RE: Response to Technical Evaluation Comments and Information Request of CES's Responses to EPA's Initial Technical Evaluation Comments and Information Requests #1-4 CES-Mendota Site Underground Injection Control (UIC) Permit Application Class VI Pre-Construction Permit Application No. R9UIC-CA6-FY20-1

### Evaluation of Applicant Responses to EPA’s Technical Review Comments on the Geologic Information in the CES-Mendota Class VI Permit Application

Figure 7. Upscaled porosity profile along the N-S cross-section.

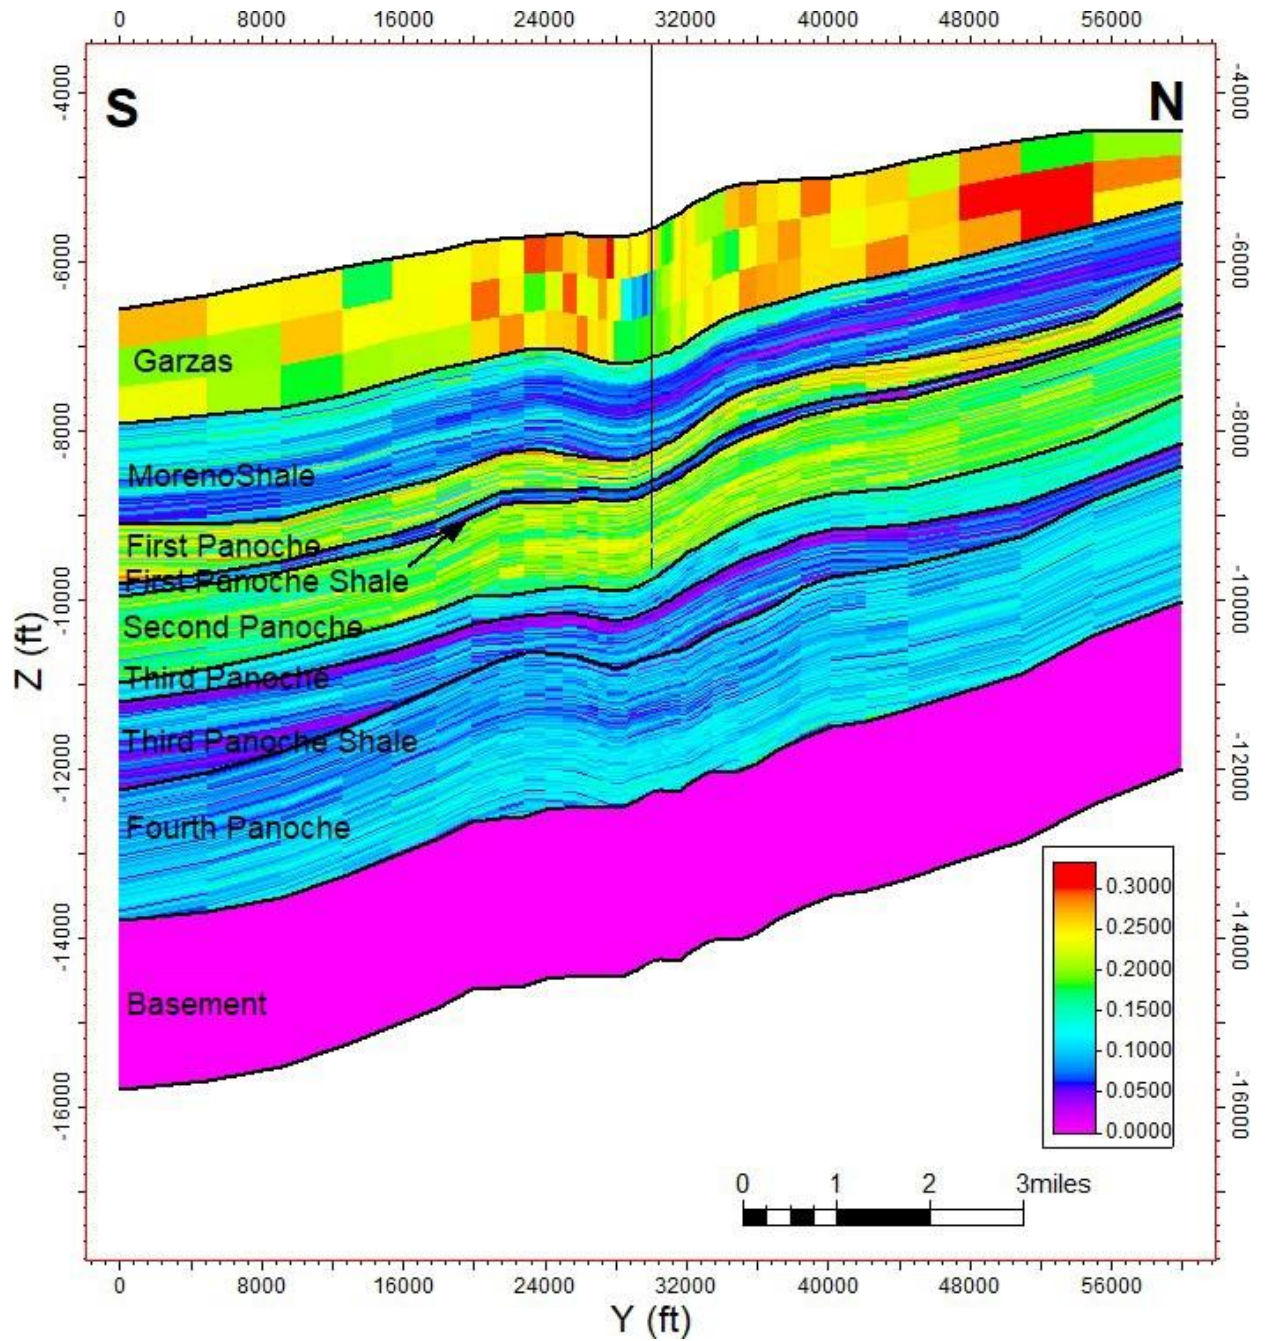
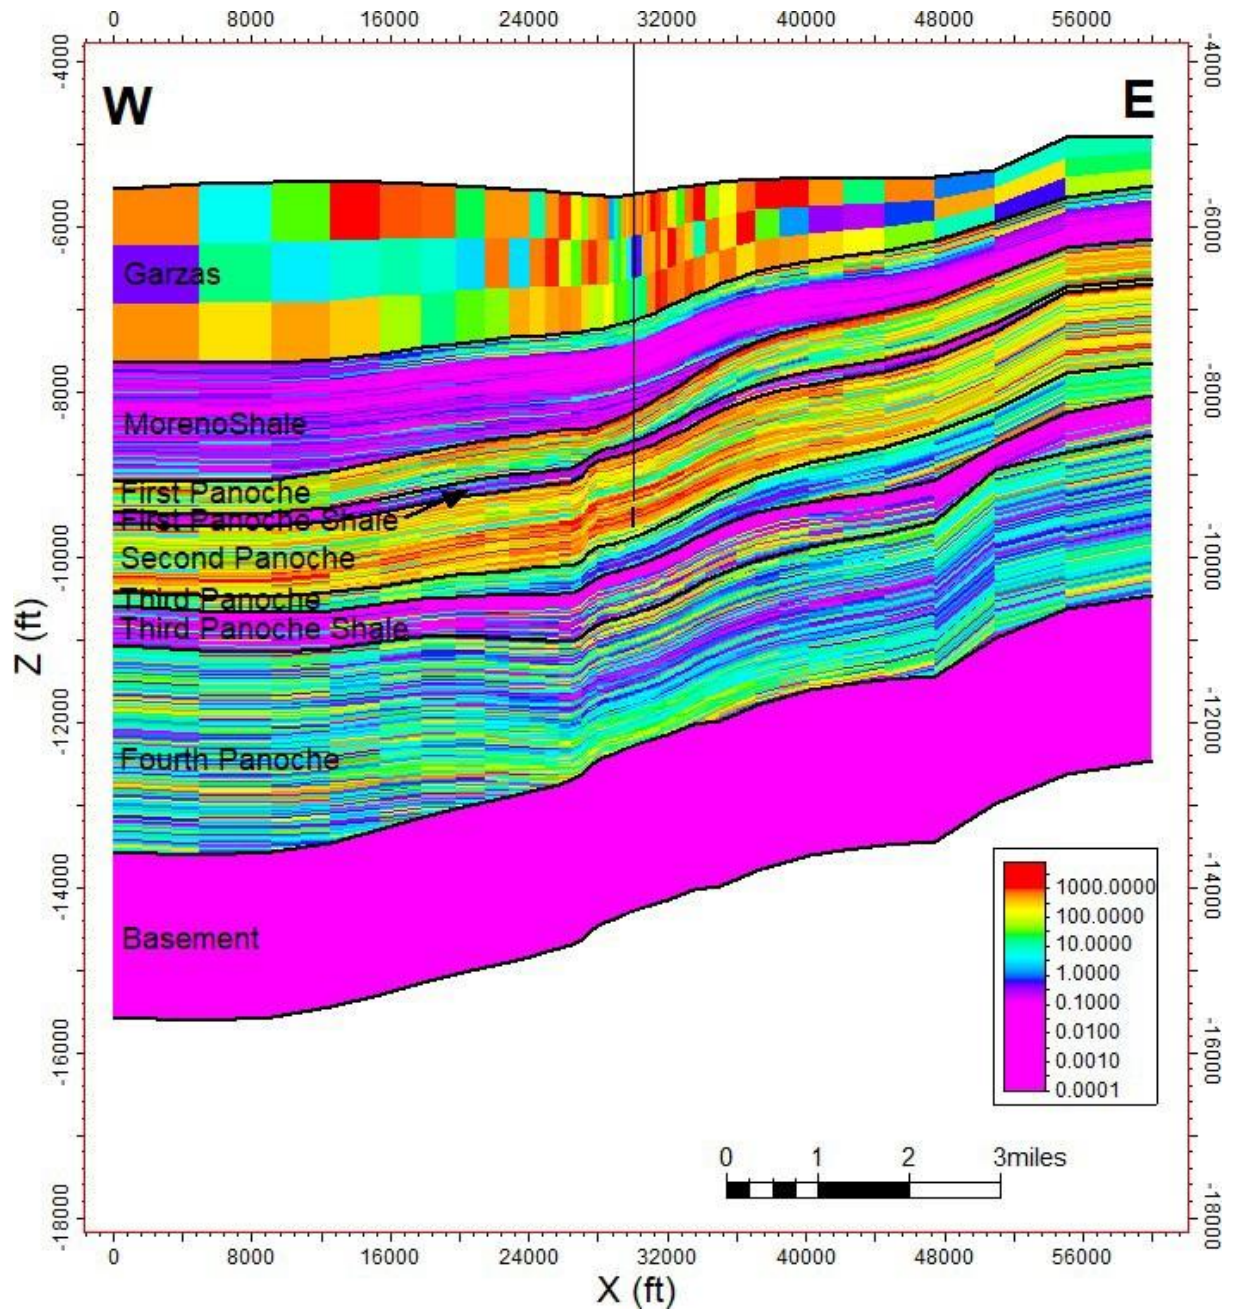
2.3.1	“The upscaled porosity and permeability graphics in Attachment B (Figures 3 and 4) would benefit from labeling for formation tops.”	<i>The figures were updated with formation tops in Figure 7 and Figure 8 (refer to Appendix A).</i>

Figure 14: BB Co. 1 wellbore after P&A operation

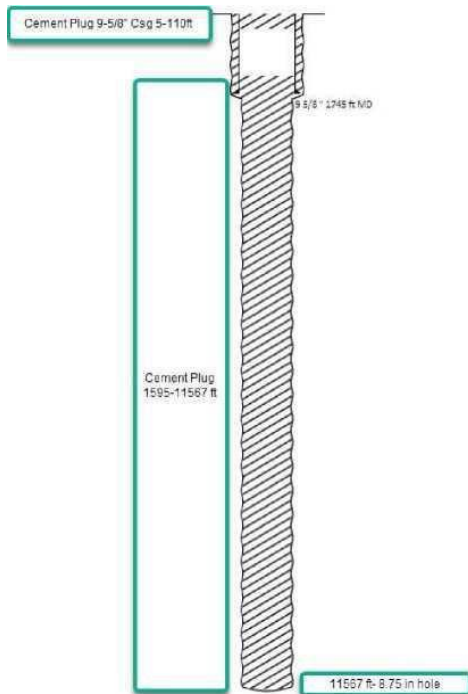
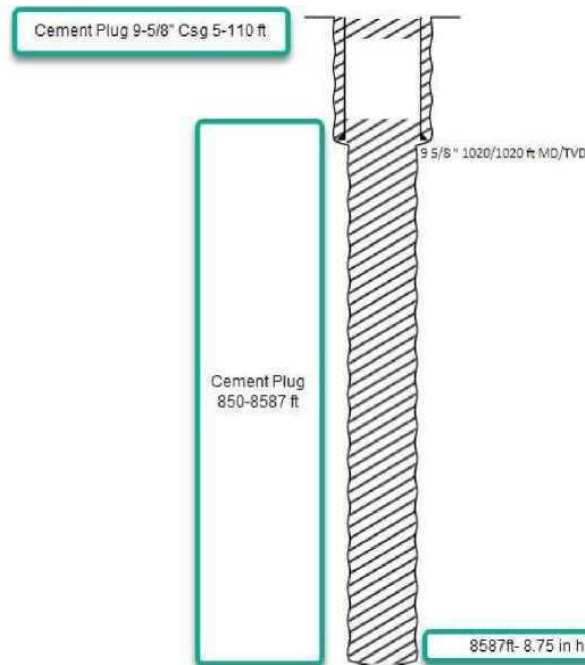
- *The plugging procedures for Amstar 1 and BB Co 1 on pages 25 and 26 reference a casing diameter of 9 5/8 inches; however, figures 14 and 15 show that the hole is 8.75 inches. Please clarify the discrepancy.*
- *This is correct. The 9 5/8-in. surface casing has drift inner diameter of 8.75 in. Therefore, an 8.75-in. hole was drilled below the 9 5/8-in. casing.*

Figure A-3. Mendota injection plug schematic.

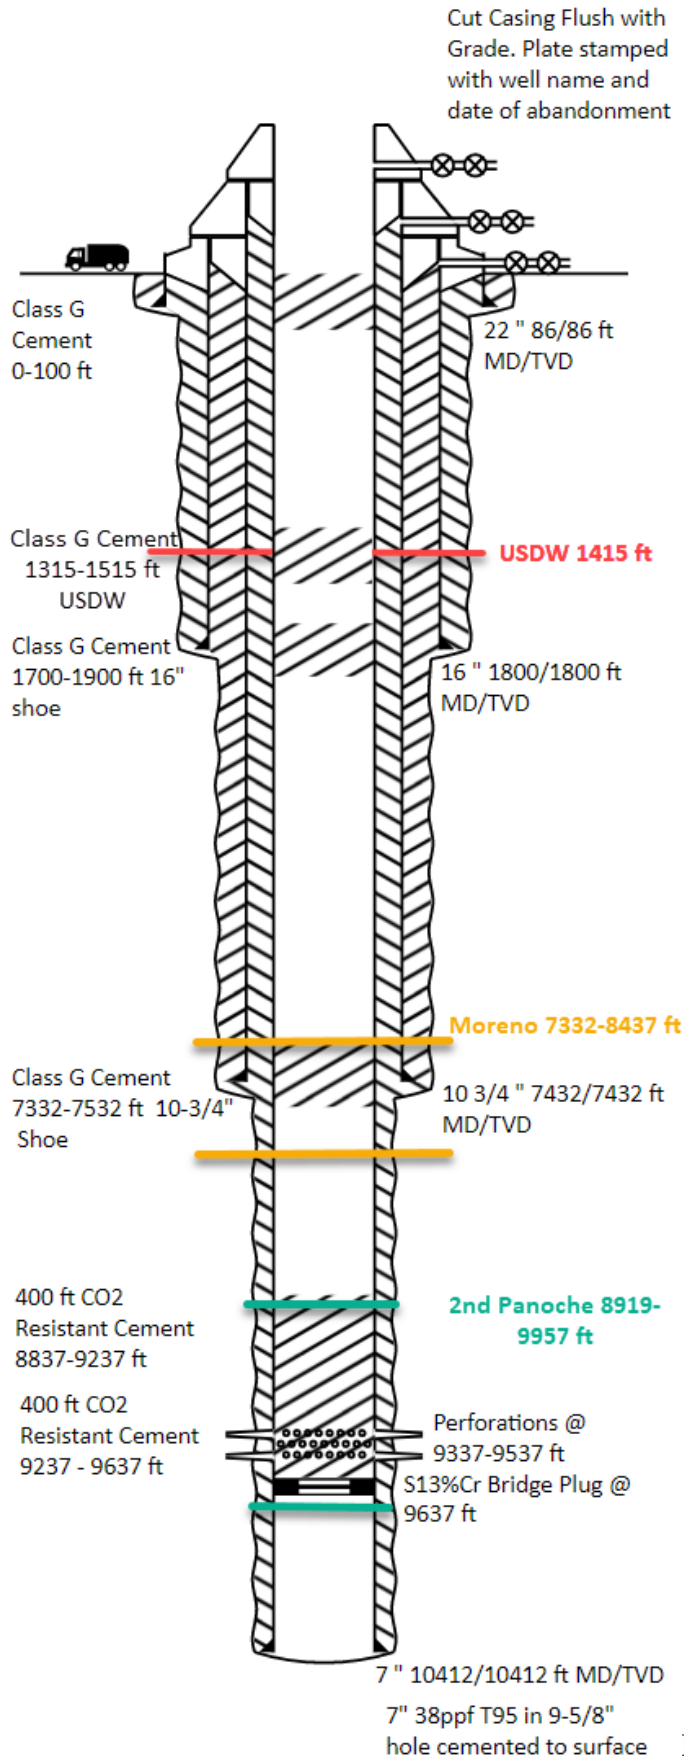
According to Figure 6.4, the perforations are 9,337 - 9,537 ft and the bridge plug is proposed to be set at 9,637 ft. This would mean that the bridge plug would be set below the injection perforations, followed by balancing a Class G cement

**EPA Evaluation of Response:** The plugging diagram on page 47 has been revised to clarify the depths of the cement plugs at the intermediate casing shoe and the base of the conductor pipe in Figure 5-2. However, no plug is provided at the base of USDWs at 1,415 feet.

- *Comment noted. CES does not anticipate entering zones of significant water or hydrocarbon saturation at the planned well plug sites. Figure 5-1 of Appendix B illustrates the Moreno and Panoche formations as well as the primary injection zone relative to the well plugging schematic.*
